**IN THE MATTER OF** Applications by the Central Plains  
Water Trust and Central Plains  
Water Ltd. to Take and Use Water  
for Irrigation in the Central Plains  
area.

**Section 42A Officer's Report**

**Report of DAVID MICHAEL SCOTT**

**Figure 1: Observed and simulated groundwater levels for well L36/0092.**

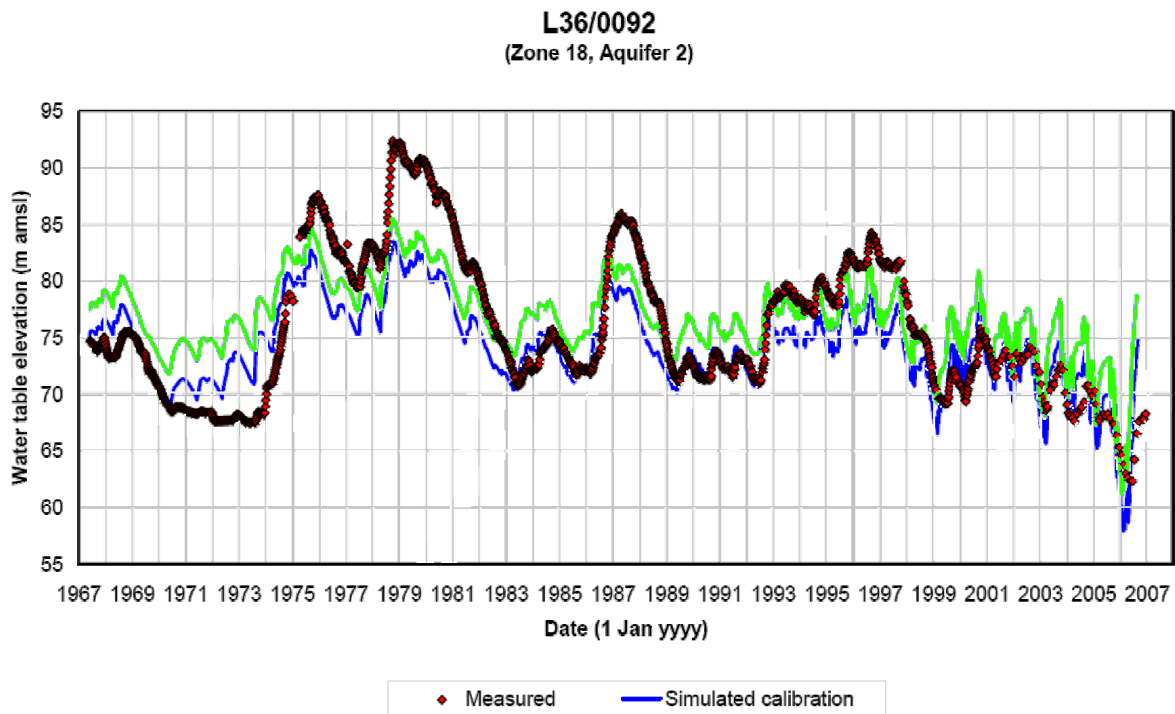
25. Figure 1 shows the match achieved between observed and simulated groundwater levels for well L36/0092 which is within the CPW scheme area. There are several aspects of this plot that give grounds for concern about the quality of the model calibration:

- The simulated groundwater levels show a seasonal fluctuation which is not apparent in the earlier half of the observed record. The later observed fluctuations are presumably the result of groundwater abstraction and the model does simulate increased seasonal amplitude over the later

part of the record. The anomaly in the earlier part of the record, which is also evident in many of the hydrographs plotted in Appendix P of Aqualinc (2007), suggests that some of the storage terms adopted in the model are inappropriate.

- In some areas of the model the simulated groundwater level rise resulting from higher than average recharge is less than the observed range (particularly in model zone 18). Since the CPW scheme would result in increased land-surface recharge this aspect of the model's performance is of particular significance. The observed rise of groundwater levels in the late 1970's can be attributed to the higher than average rainfall which occurred over several years. The fact that in some areas the model under-estimates that response suggests that it is also likely to under-estimate the groundwater level rise resulting from the CPW scheme.

- The blue line in Figure 1 shows the groundwater level simulated using Model 2. The green line was calculated using Model 2A. The later model included modifications to improve the simulation of Selwyn River flows but this appears to have been achieved at the cost of some degradation of the ability of the model to match the response to longer timescale changes in land-surface recharge.

**Figure 2: Model 2 Observed and simulated flow (from Appendix Q, Aqualinc 2007) plus spot gaugings (◇) from ECan database.**

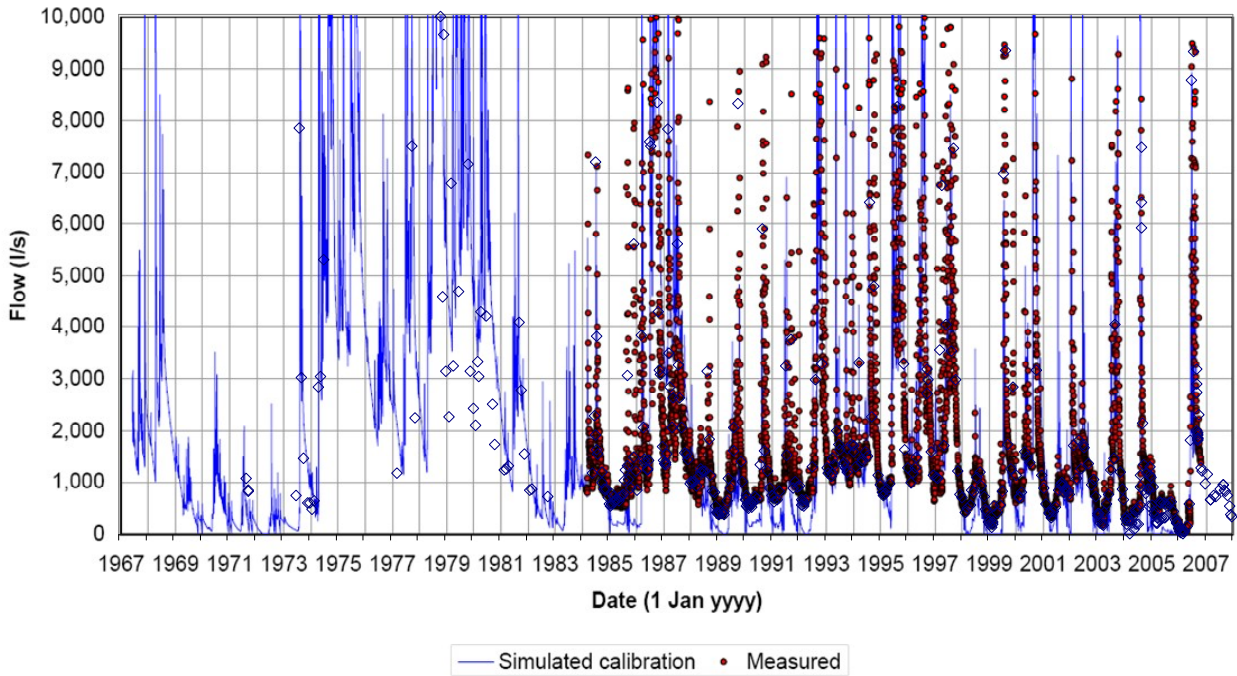
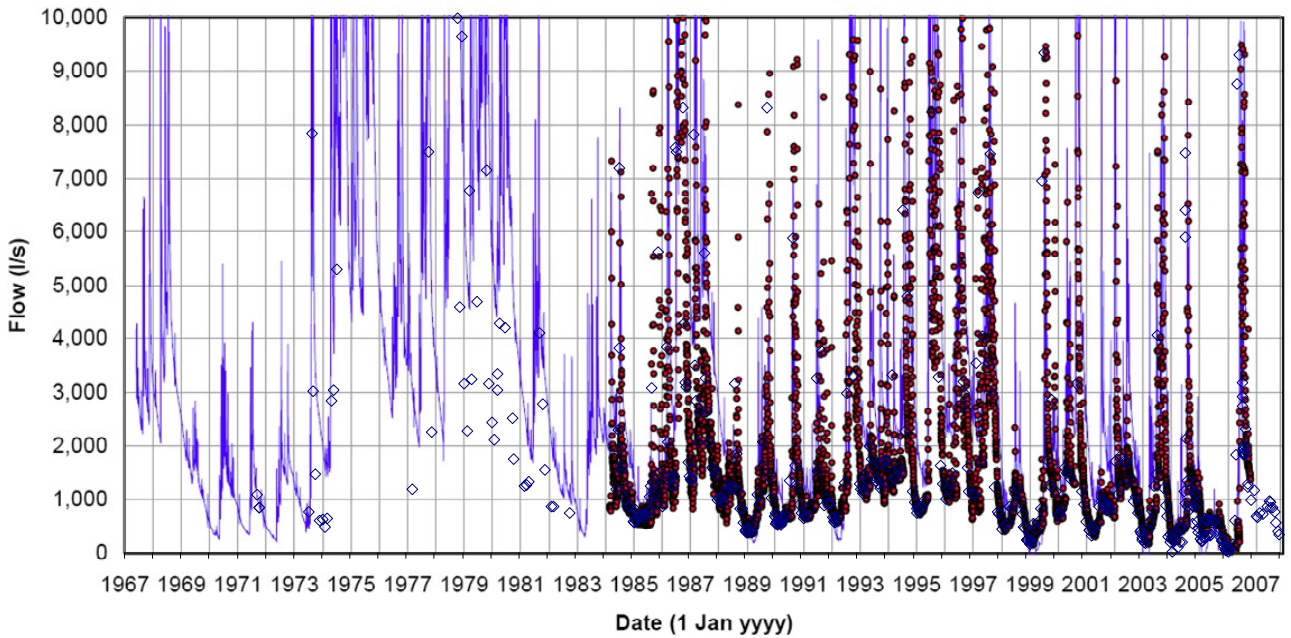
- 28.** The CPWES scenario predicts very significant increases in the flow in the Selwyn River at Coes Ford so it is important to look more closely at this aspect of the model's performance. The Model 2 and Model 2A simulations of historic flow for that site are shown in Figures 2 and 3 respectively. Flow recording commenced at the Coes Ford site in 1984 and model calibration has attempted to match the flow record since that date. The Model 2 under-estimation of low flow is clearly evident in Figure 2. Figure 3 shows the significant improvement made to the Model 2A version in terms of matching the Selwyn River low flow.

- 29.** The Council gaugings database contains records of spot flow gaugings at the Coes Ford site starting from 1971 and I have superimposed those on Figures 2 and 3. The observations prior to 1984 suggest that both models perform less satisfactorily when conditions are likely to lead to higher base flows and that the modifications made to improve the reproduction of very low flows has degraded the model performance at higher flows.

- 30.** It is difficult to fully understand what interactions are at work here. On seeing these latest results I requested a copy of the stream package inputs referred to in Appendix A of Aqualinc (2007) but at the time of writing had not received that additional information. My provisional conclusion is that the model parameters may be set in such a way that groundwater drains too easily from storage when groundwater levels in some areas of the model are above some threshold. That would account for the under-estimation of groundwater level increases and over-estimation of higher than average baseflow.

Figure 5: The Christchurch groundwater protection zone superimposed upon simulated flow directions (Weir 2008, Status quo average period (1 March 1994) – shallow aquifer).

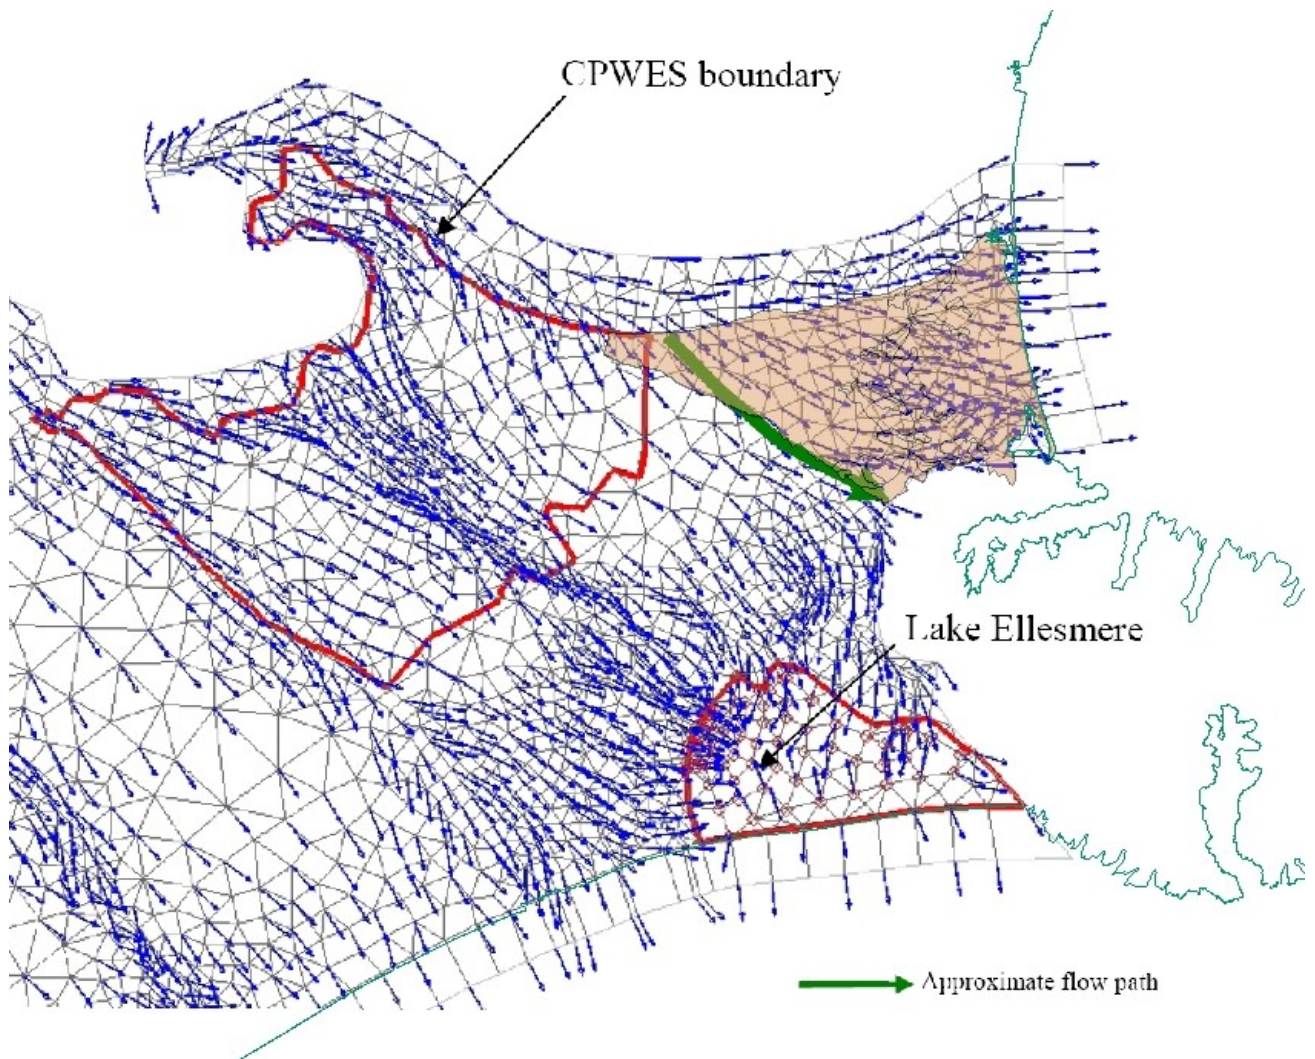
56. Weir (2008) describes the steady-state flow directions simulated for the Status Quo and CPWES scenarios. The simulated shallow groundwater flow directions indicate a groundwater divide that is comparable to that implied by the Groundwater Protection Zone proposed Variation 6 of the Natural Resources Regional Plan. The extent of that zone was based on a qualitative evaluation of shallow groundwater flow directions inferred from piezometric contours, supporting water quality data and geological mapping. In Figure 5 I have superimposed the protection zone on to the plot of flow directions (Status Quo average period). This provides only an approximate comparison since I did not have access to a geo-referenced version of the flow direction plot<sup>3</sup>. Nevertheless it supports the general contention that discharge from the CPW scheme will largely flow in the direction of Lake Ellesmere.

57. Comparison of the Status Quo and CPWES flow direction plots (Appendix I, Weir 2008) suggest that on a regional scale groundwater flow direction may be unchanged by the CPW scheme. This seems a reasonable assessment even though it might at first be seen as contradicting the statement that the loss of recharge from the Waimakariri River will be offset by increased land-surface recharge as a result of irrigation from the CPW scheme.

**Figure 4: Alternative aquifer 4 & 5 hydraulic conductivities.**

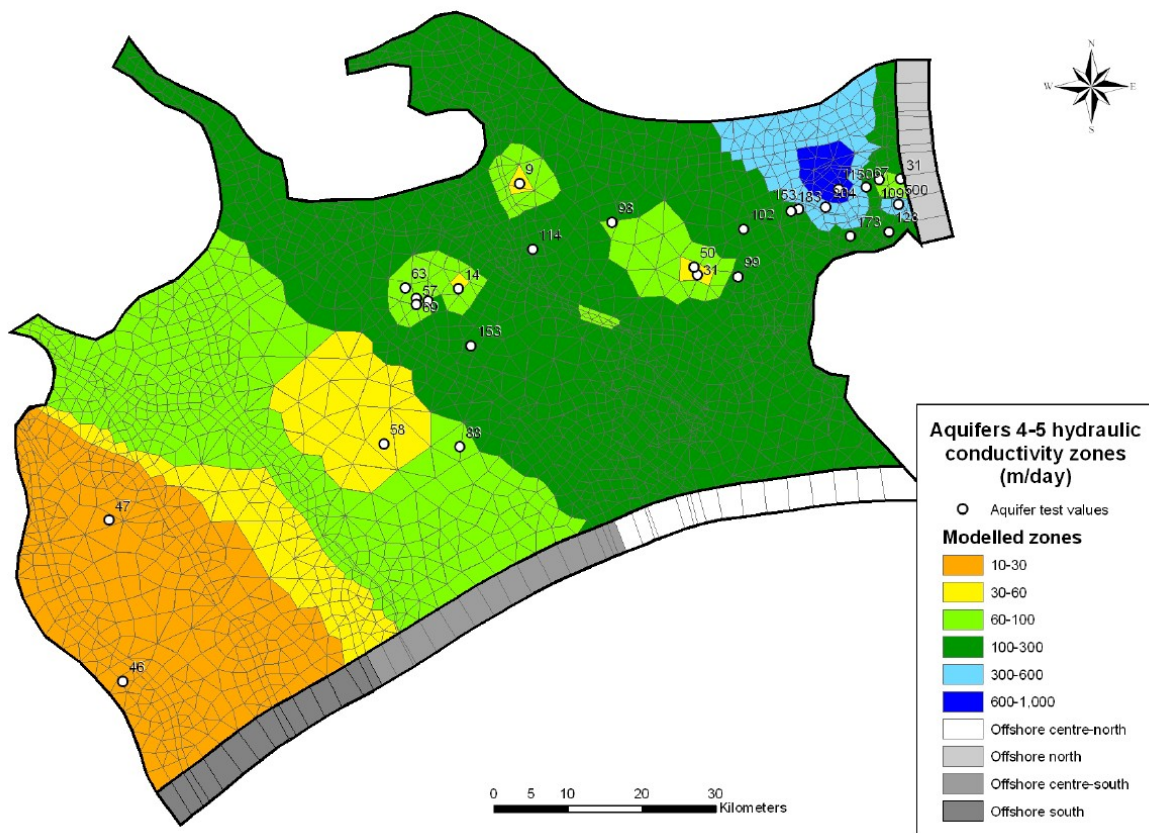
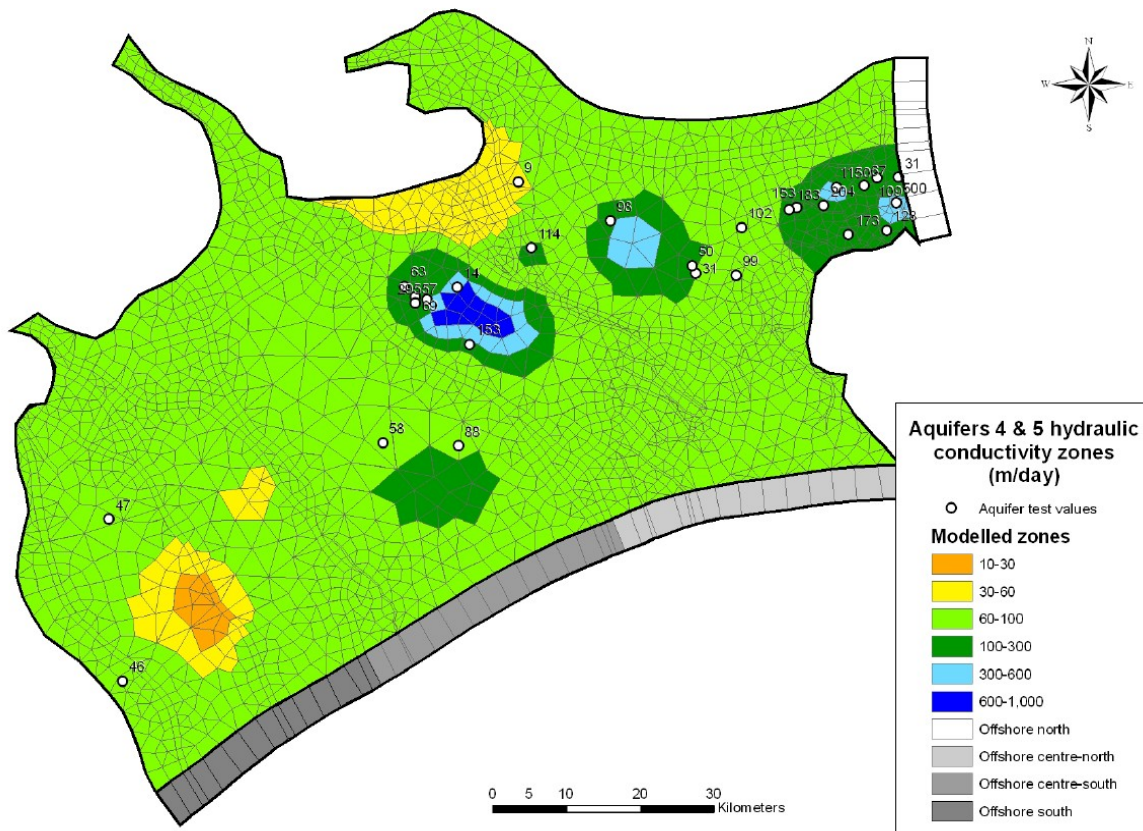
58. The modelled flow directions suggest that deeper groundwater under the CPW scheme area could be flowing more directly towards Christchurch (in model aquifers 4 & 5). The particle tracking calculations (illustrated in Appendices J & K, Weir 2008) show shallow groundwater from within the CPW scheme area flowing towards Lake Ellesmere and groundwater in the Christchurch water supply area as being predominantly originating from the Waimakariri River or from within the Groundwater Protection Zone. One of the particle tracks suggests the potential for groundwater flow from the upper plains area within the CPW scheme area to reach Christchurch.

59. Particle track calculations are dependent to a large extent on the pattern of hydraulic conductivities adopted in the model. It should be remembered that the model attempts to represent the complexity of the real world using a simplified description of hydraulic conductivity and there is considerable uncertainty involved in these descriptions as illustrated by the alternative versions adopted for Aquifer 4-5 hydraulic conductivity zones for Model 2 (Aqualinc 2007) and Model 2A (Weir 2008) – see Figure 4. I expect that very different particle tracks would result if the Aqualinc (2007) hydraulic conductivity pattern had been used and in my opinion the particle tracks provided in Weir (2008) should be regarded as speculative.
